**From:** J Sevilla [qmakeda@chesapeake.net]  
**Sent:** Friday, July 09, 2010 3:58 PM  
**To:** CalvertCliffsCOLAEIS Resource; Quinn, Laura; woody.francis@USACE.ARMY.MIL; Steckel, James; Arora, Surinder  
**Cc:** Peter Saar; Peter Vogt; Michael Mariotte; Allison Fisher; Paul Gunter; Bruce Gordon; Chris Bush; William Johnston; fabiada@yahoo.com; Timothy Flaherty; harold thornburg  
**Subject:** June Sevilla submission to DEIS (DRAFT NUREG 1936) and FSAR - #1 of 3 emails  
**Attachments:** June 26 2010 ltr-Kidwell-Sevilla-FSAR Rev 6 analysis.pdf  
**Importance:** High

RE: Comments on CCNPP Unit 3 FSAR Rev 6 Section 2.5 “Geology, Seismology, and Geotechnical Engineering”

Encl 1 – Gernant's Fig 4, page 10 of 1970 Maryland Geological Survey,  
Report of Investigations No. 12:

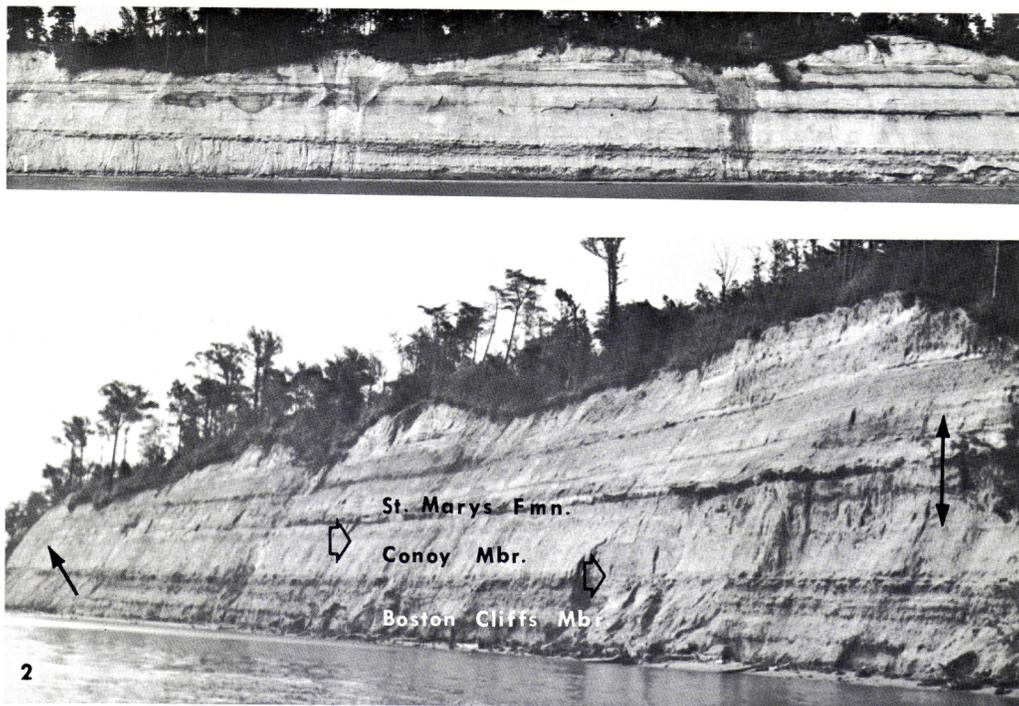
Concerning the apparent lack of other published observations on structural warping (p. 2-1118), Gernant (1970, Maryland Geological Survey, Report of Investigations No. 12) also detected the notable change in dip of Miocene strata within the Conoy Cliffs and also attributed it to folding (see Encl 1: Gernant’s Figure 4, p.10, included below). This is one published paper missed in the FSAR review, albeit directly relevant. [The one outcrop photograph provided in the FSAR (Fig. 2.5-44) is a highly oblique view of the same Conoy Cliffs, taken from a large distance, that will minimize the viewers ability to appreciate the feature. It concerns me that this might have been the only perspective FSAR authors had, other than perhaps a highly foreshortened view from the narrow beach at the base of the Conoy Cliffs.] Genant and I both recognized the involvement of folding in the creation of the reversed dip of Choptank Formation beds within the Conoy Cliffs, despite the erosional nature of the stratigraphic discontinuity surface(s) that define those beds. (Paleo)erosion is commonly localized in areas of relative uplift (regardless of whether uplift is antecedent/inherited, syn-depositional, or post-depositional). The erosional nature of some of the bed contacts that Gernant and I traced is thus not mutually exclusive with the existence of structural warping as a contributing – or even a primary – control on observed changes in bed elevation, contrary to the implication of the FSAR (e.g.. p. 2-1095, “undulations typically represent erosional features...”). My 1997 paper is explicit that, although some variation in elevation of beds (more precisely, discontinuity surfaces) within the larger Calvert Cliffs are entirely erosional in nature (representing incised channels), changes in elevation near the CCNPP and some others appear to instead be structural warps, at least in part (1997 JSR paper, p. 324). That assessment reflects an explicit rejection of the hypothesis of erosion. In fact the lack of any sedimentary response to the relative (paleo)high on the south side of Moran Landing– St Marys beds do not thin or become coarser over it -- argues that the offset in elevation here is post-depositional (notice the continuity of facies tracts within SM units that can be traced across the postulated fault plane in my 1997 cross-section). The FSAR authors seem to be broadly skeptical of changes in bed elevation as evidence of structural features (e.g., in also rejecting McCartan and others’ postulated monoclines, p. 2-1093, -1095, -1116, -1199, etc.) and to be unattuned to using sedimentologic/ stratigraphic evidence for growth faulting and folding. I, too, would not use it as definitive evidence. However, I would expect an explicit testing of faults hypothesized on this basis using more definitive methods (dedicated boreholes, trenches, seismic profiling) before rejecting it, especially when placement of a public facility was an issue.

7. (**Sevilla Exhibit 7**) Dr. Robert Gernant, in the 1970 publication of the Maryland Geological survey, “Report of Investigations No, 12”, page 10, Figure 4, published his picture of Calvert Cliffs at “Camp Conoy, YMCA” because he noticed the unusual tilt of the beds in that area of Calvert Cliffs. Dr Gernant’s picture is the north cliff view of the same area labeled by Dr. Kidwell in her 1997 JSR study, page 324, Figure 2, as “Conoy Landing”(Sevilla Exhibits 5 and 6).

8. Dr. Gernant’s publication in 1970 led Dr. Kidwell to examine very carefully Calvert Cliffs especially at the Conoy Landing area, because of the unusual tilt of the beds downwards towards the north. This tilt contrasts the usual tilt of beds downwards towards the south. The significance of this unusual northward tilt is that the beds have been arched slightly by deformation. Such “folding” of the beds is commonly associated with faults.

Encl 2b – Sevilla Exhibit # 4, PSC CPCN Case No. 9218 testimony – Kidwell:

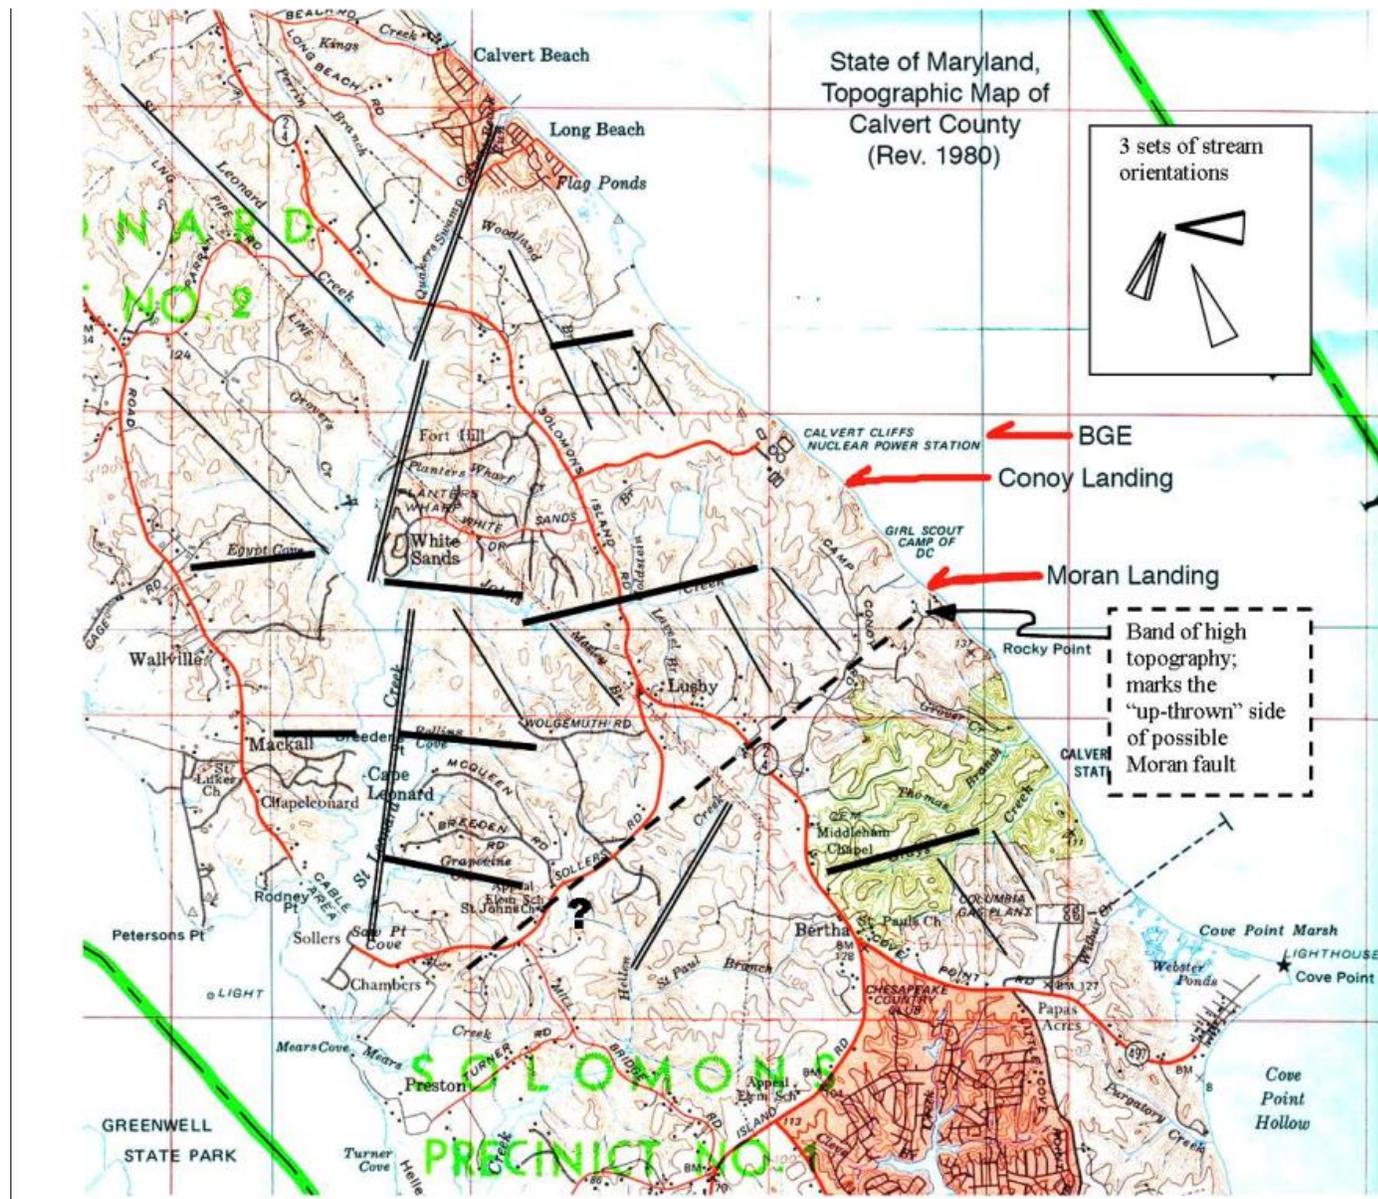
1. Many streams have suspiciously long straight stretches and make approximately right-angled turns, which is typical of terrains where there is an underlying structural (tectonic) control on drainage.
2. This contrasts with the "dendritic" (root-like) pattern that typifies terrains lacking any structural control on the weakness of the underlying rocks.

3. Tenured and experienced geologists Dr. Susan Kidwell, Dr. Peter Vogt, and Dr. Curt Larsen concur that in this part of Calvert County there is
  - a. a set of stream segments with a basically East-West orientation (indicated by bold solid lines on map; for example, Johns Creek, which heads east toward the southern end of CCNPP property),

- b. a second set of stream segments having a South-Southwest orientation (doubled-lines; for example, St Leonard Creek and its overland extension to Long Beach), and

- c. a third set of mostly minor streams having a South-Southeast orientation (many fine solid lines).
4. The “overlaid stream line segments” on the topographical map have been positioned slightly east or north of the relevant stream so as not to obscure the trace of the stream on the map or the labels providing the stream names.

5. The bold dashed line on the map, running Northeast - Southwest, marks a band of topographically high land that extends from the Calvert Cliffs over to the Patuxent River:

- a. It begins under the Moran property and
  - b. coincides with Sollers Road for a considerable stretch and in the direction of the mouth of Mears Cove on the Patuxent River.

- c. This dashed line does not mark the trace of the postulated Moran Fault, but rather the topographic high running land along the edge of the "up-thrown" block. The fault line would be located on the north side of this dashed line within the order of a quarter mile.

6. The location of the CCNPP Unit 3 Cooling Tower, when measured relative to the dashed line is about a half mile northwest of the dashed line; even lying closer to the postulated Moran Landing Fault (less than a half mile).
